SUBJECT: ISSUANCE OF AMENDMENT NO.23 TO FACILITY OPERATING LICENSE NPF-68
AND AMENDMENT NO. 4 TO FACILITY OPERATING LICENSE NPF-81 - VOGTLE
ELECTRIC GENERATING PLANT, UNITS 1 AND 2 (TACs 73125/73126)

The amendments revise requirements regarding containment tendon surveillance.

SAFETY EVALUATION BY THE OFFICE OF NUCLEAR REACTOR REGULATION
RELATED TO AMENDMENT NO. 23 TO FACILITY OPERATING LICENSE NPF-68
AND AMENDMENT NO. 4 TO FACILITY OPERATING LICENSE NPF-81
GEORGIA POWER COMPANY, ET AL.
DOCKET NOS. 50-424 AND 50-425
VOGTLE ELECTRIC GENERATING PLANT, UNITS 1 AND 2

FIGURE 3.6-1

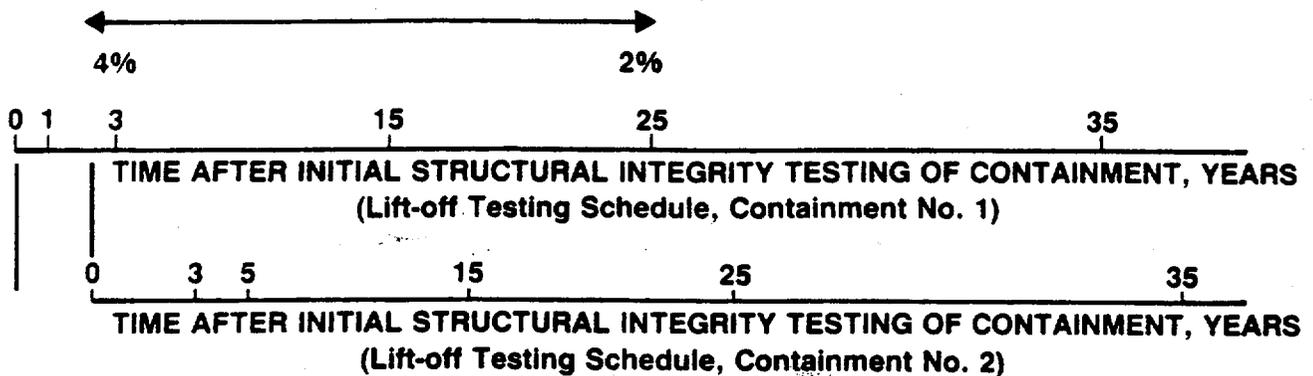
The structural integrity of the prestressing tendons of the containments shall be demonstrated at the end of 1, 3, and 5 years following the initial containment vessel structural integrity test and at 5-year intervals thereafter. For combined inspections of two containments in a plant, lift-off testing will be performed in accordance with the inspection schedule shown in Figure 3.6-1.

be detensioned on Unit 1 each time lift-offs are performed on Unit 1 per Figure 3.6-1. One tendon shall be detensioned on Unit 1 each time lift-offs are performed on Unit 2 per Figure 3.6-1. A randomly selected tendon shall be essentially completely detensioned in order to identify broken or damaged wires and determining that over the entire length of the removed wire sample (which should include the broken wire if so identified) that:

- a. The containments are identical in all aspects such as size, tendon system, design, materials of construction, and method of construction. The tendon system for Unit 2 does not provide for detensioning. Detensioning can be performed only on the Unit 1 tendon system.
- b. The 1-year inspection for Unit 2 will consist of a visual inspection only. No lift-off testing will be performed on Unit 2 until the 3-year inspection.
- c. There is no unique situation that may subject either containment to a different potential for structural or tendon deterioration.
- d. The Unit 1 and Unit 2 surveillances may be performed back-to-back to facilitate detensioning of Unit 1 tendons during the Unit 2 surveillance.
- e. In order to perform back-to-back surveillances on Units 1 and 2, the Unit 1 10-year surveillance and the Unit 2 5-year surveillance are to be performed between 5/1/95 and 11/1/95.
